## ATTACHMENT B

Project: City of Fresno Animal Shelter

**EXHIBIT B**  
**PRE BID RFIS**

## RFI 0002 - Building A - Built-in Tall Cabinet Elevations

**C1.2**

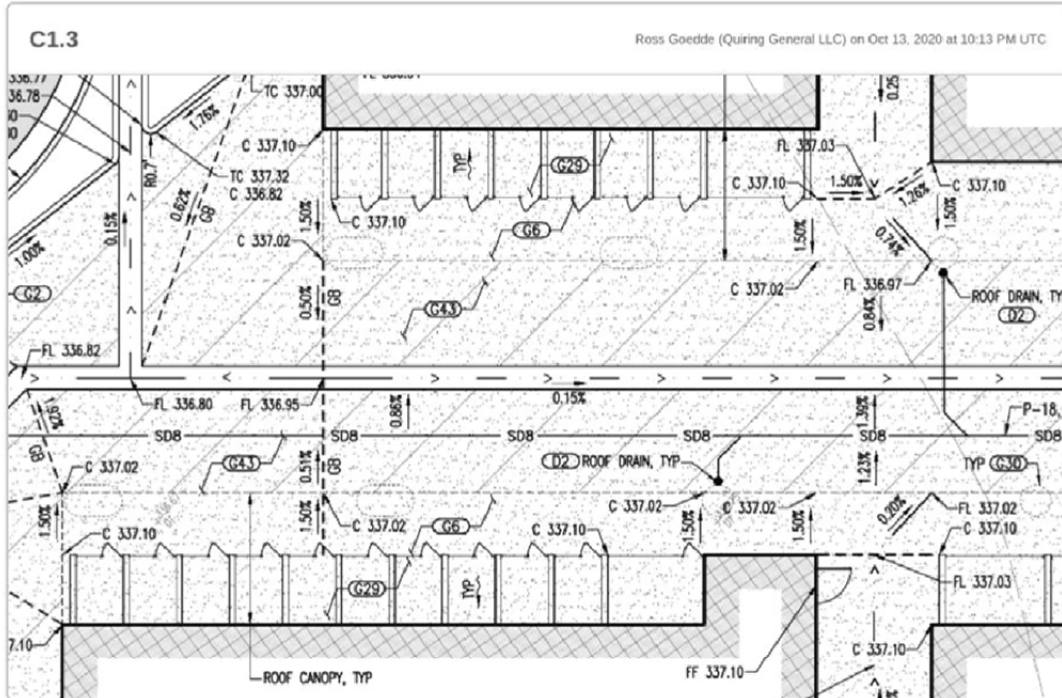
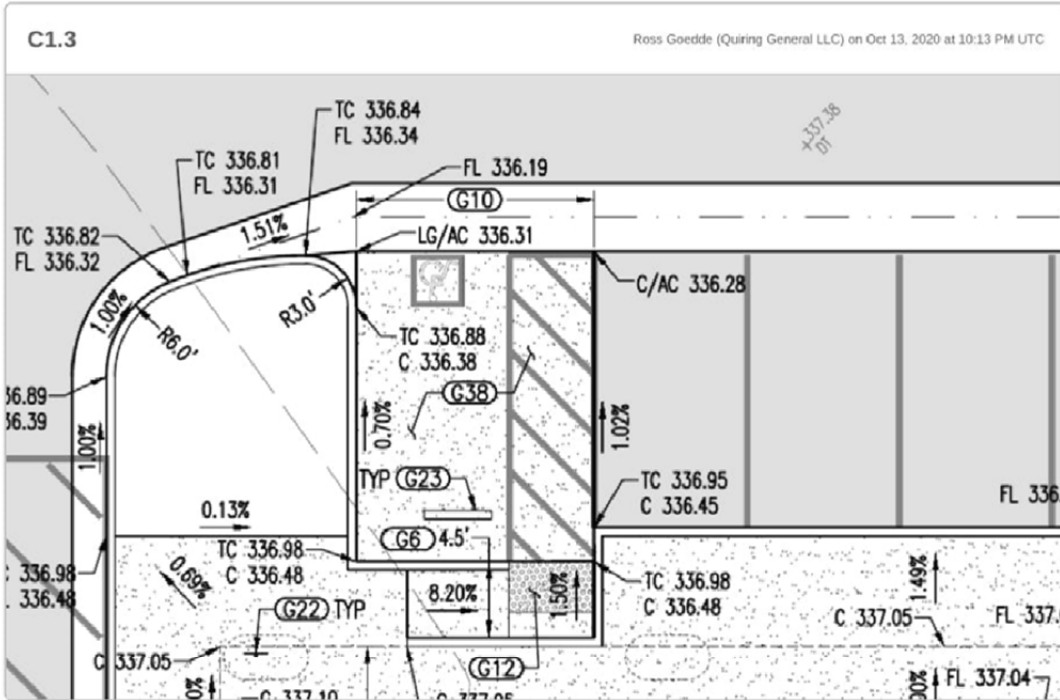
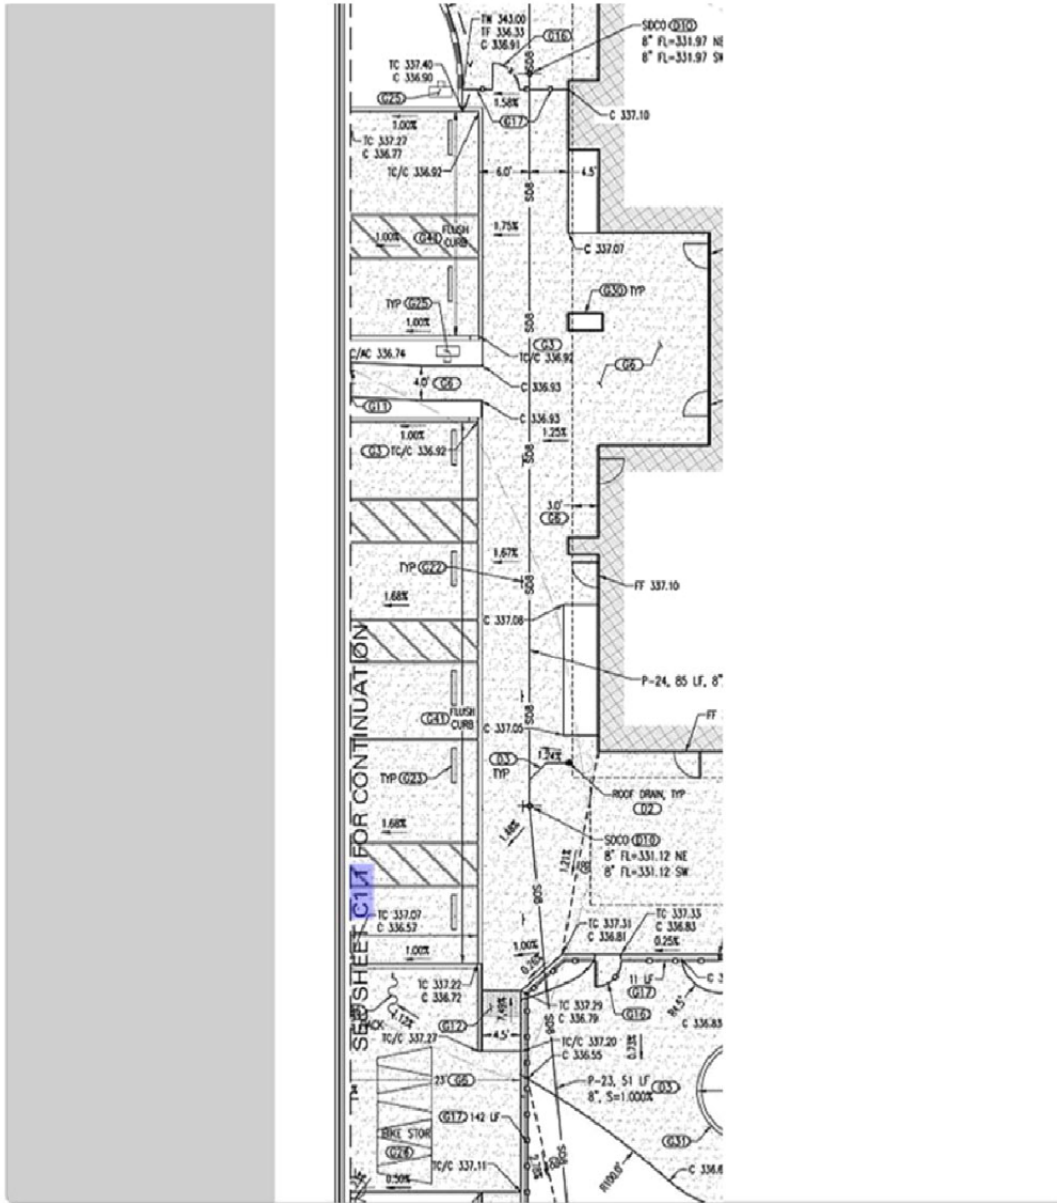
On the W side of Bldg A, the handicap concrete stalls do not have a callout. On the N side of Bldg B, the handicap stall is called out as G38. Please confirm that the handicap stalls along Bldg A should be G38.

The site concrete between the various buildings is typically called out as G6 or G43. Please confirm the delineation between these two different concrete sections. Please confirm that, generally, G6 is to be installed under the building roof line, while G43 is to be installed in uncovered areas.

1. The handicap concrete stalls along building A are G38 keynote type concrete.
2. The keynote G6 is sidewalk concrete and applies under the building roof line while keynote G43 concrete light duty vehicular rated concrete and is delineated by a hatch between buildings.

## RFI 0008 - Miscellaneous Casework Questions

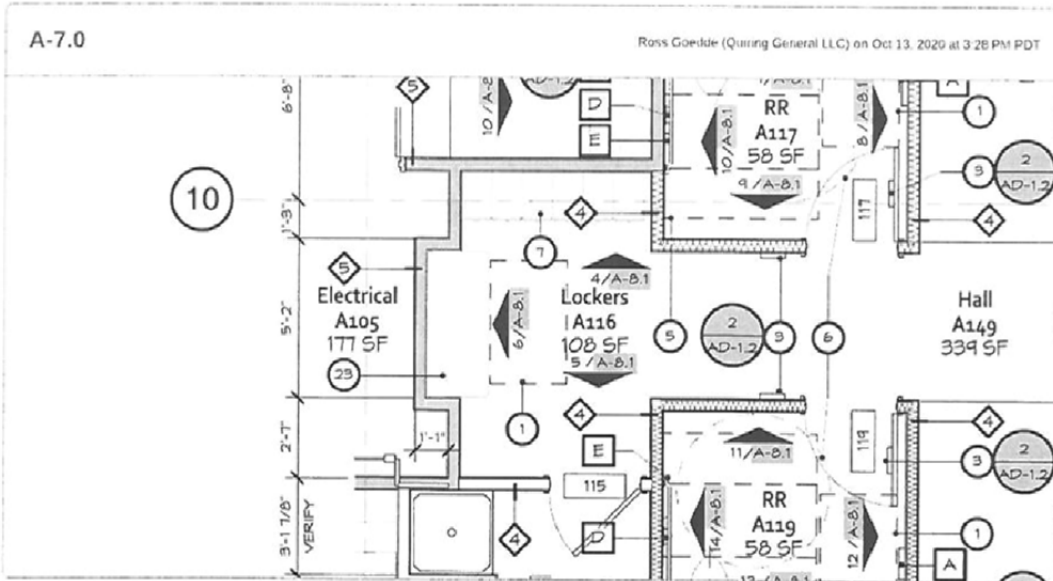
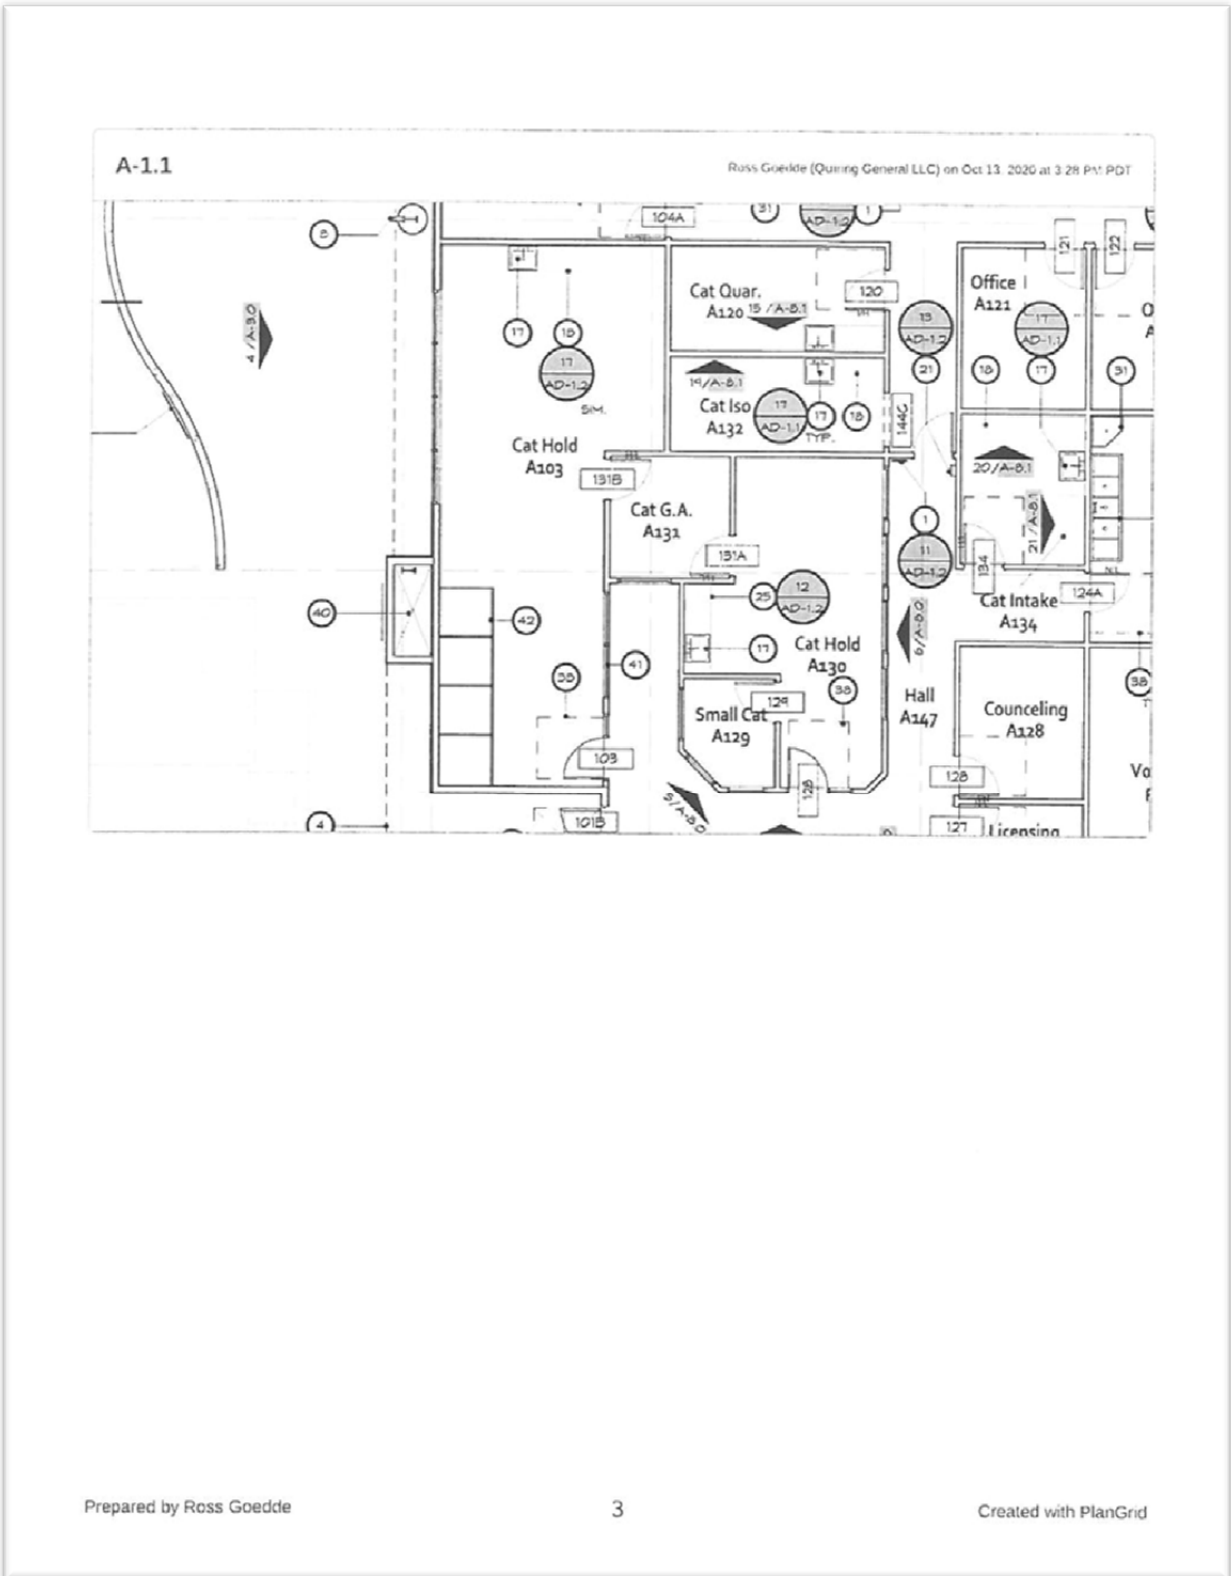
Elevations for rooms A103 and A130 are not shown on the A-8.X sheets. Please provide elevations for this casework.

*A-103 & A130 shall match A120 & A132 - 15/A-8.1 & 19/A-8.1*  
For the lockers in A116, please confirm that these should have an integral lock with a number identification for each. Please provide specifications for any specialty hardware. *NOT REQ'D - PROVIDE LOOP HANDLES FOR 1% OF PROVIDED LOCKERS (MIN OF 1)*  
Please provide the finish for the bench in room A116.

### Site Concrete

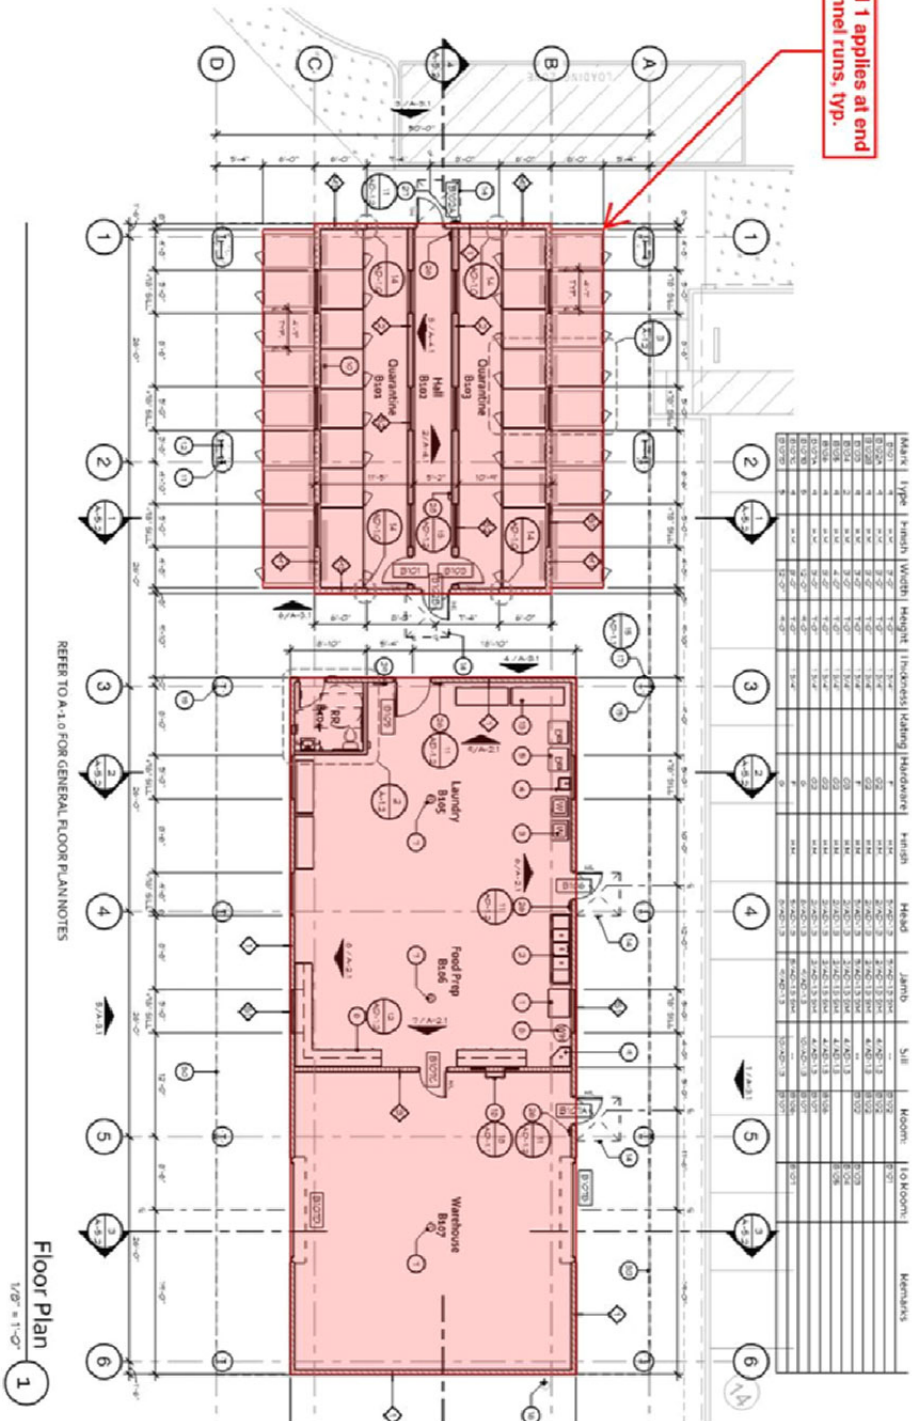
- All flatwork outside of the **RED** highlighted zones

**Extracted from sheet A-1.2**

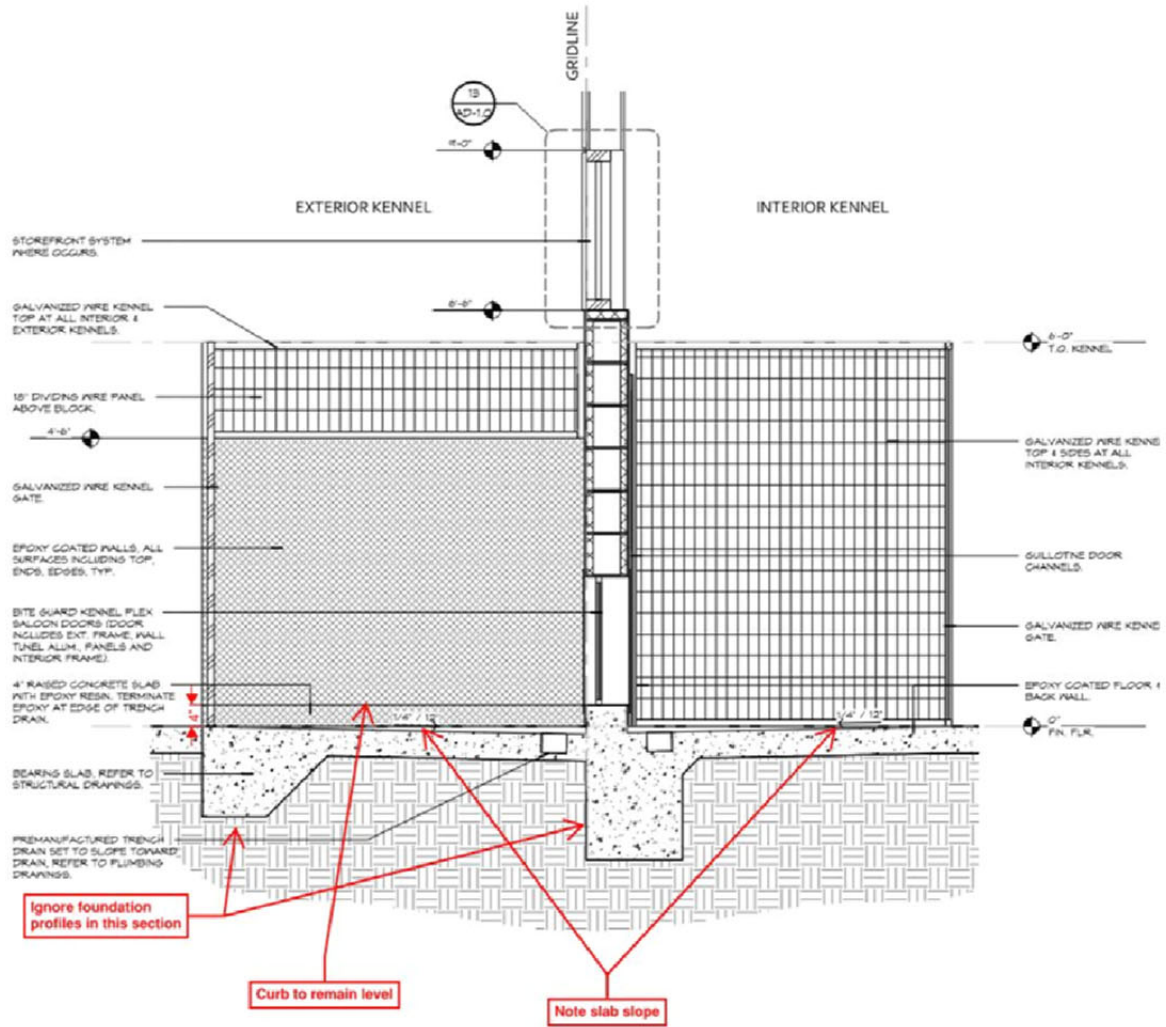
Detail 1 applies at end of kennel runs, typ.

- All CMU to sit on a concrete curb 4" AFF

## DETAIL 1

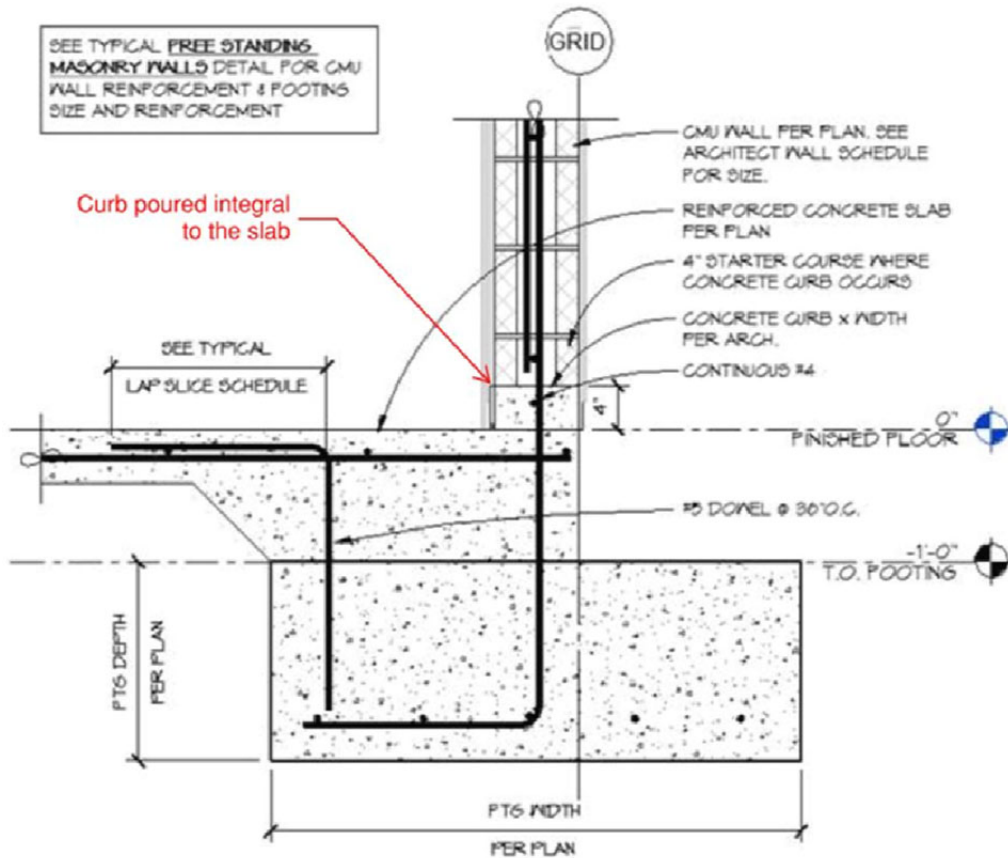
TYPICALLY APPLIES AT BUILDING ENCLOSURE WALLS  
AND END OF KENNEL RUNS

## DETAIL 2

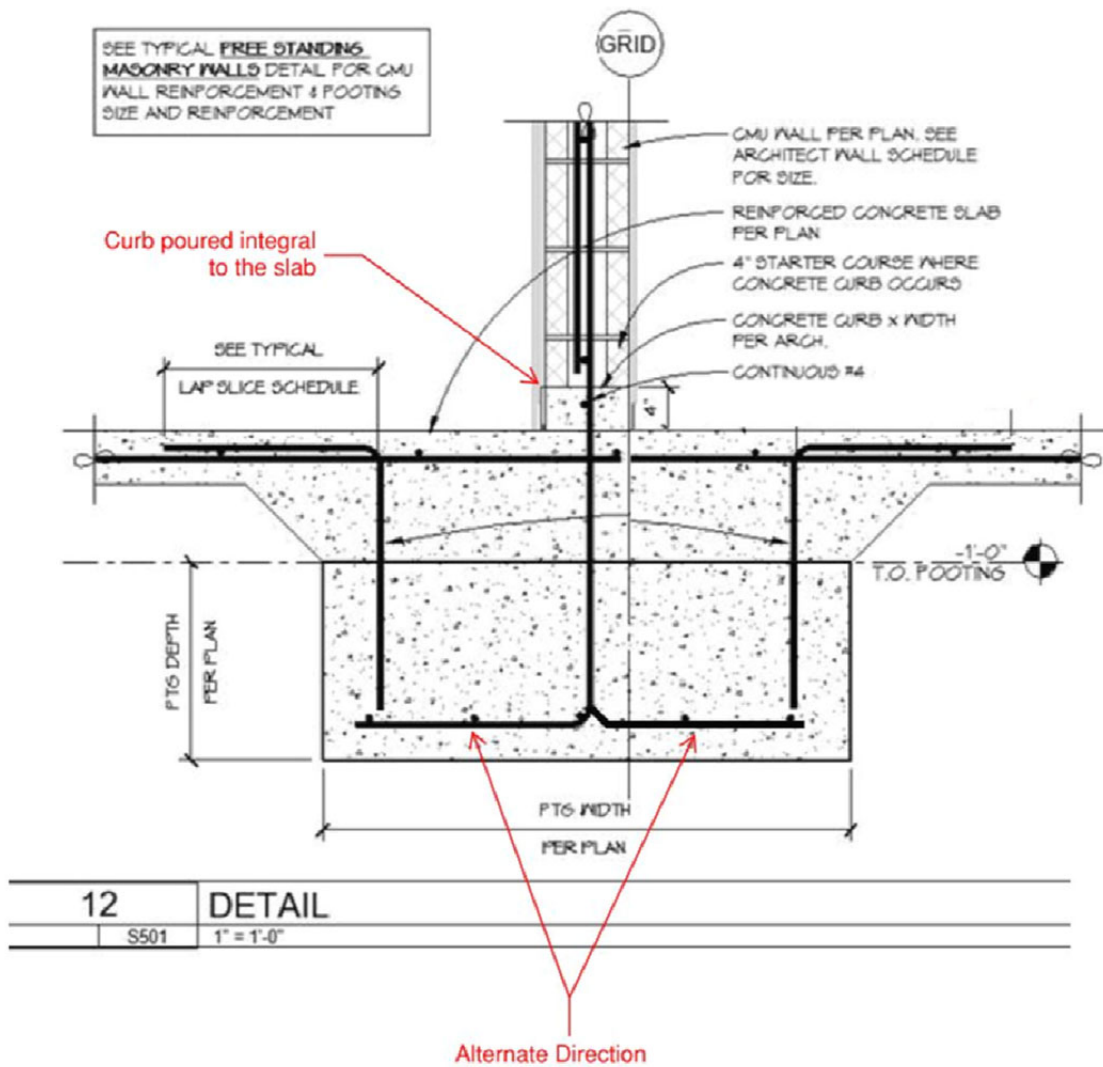
TYPICALLY APPLIES AT KENNEL DIVIDING WALLS

**Extracted from comments on sheet E9**

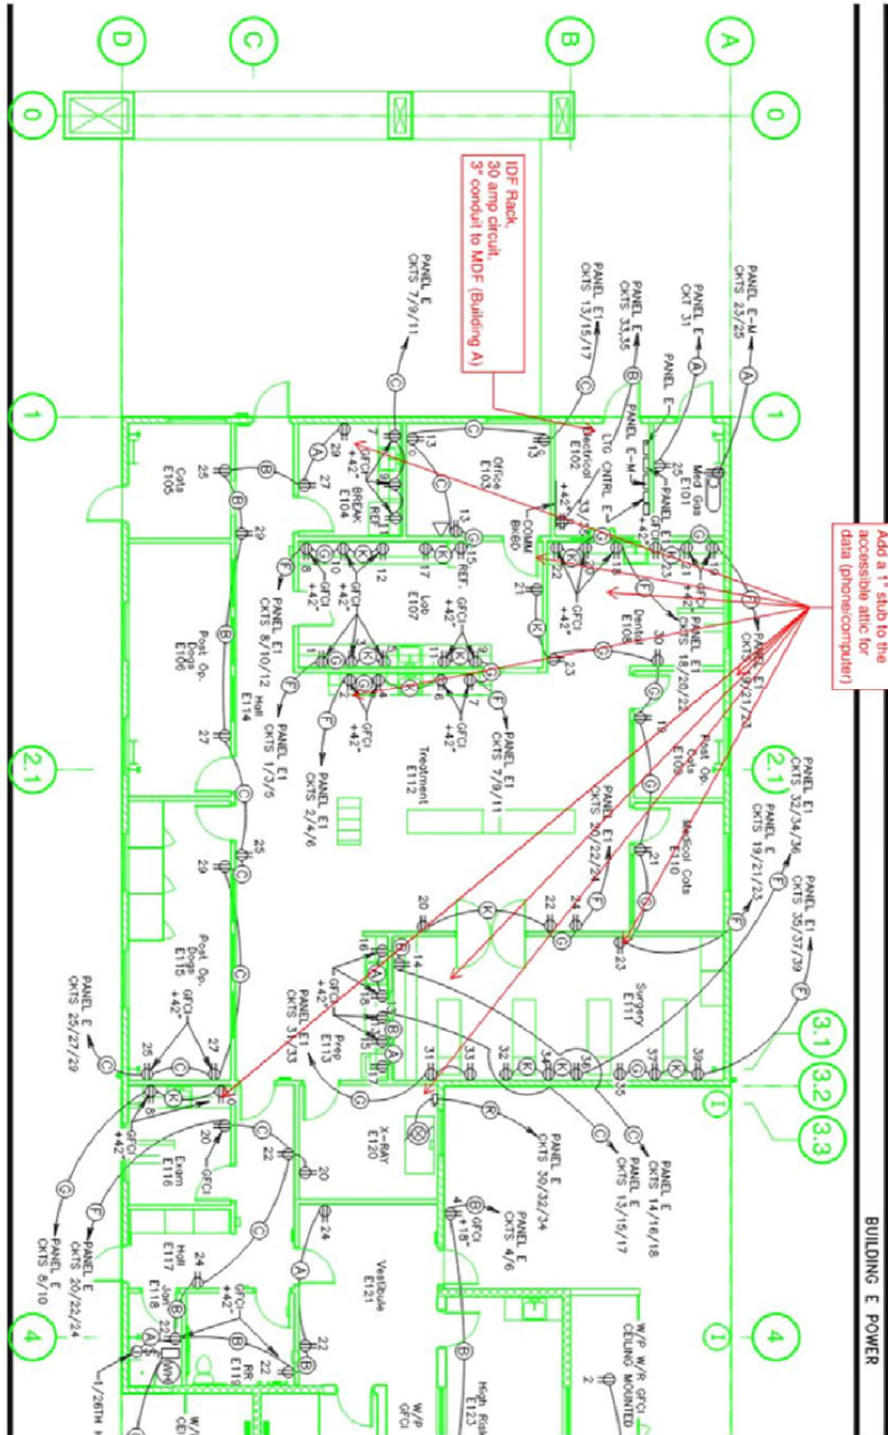
Add a 1" stub to the accessible attic for data (phone/computer)
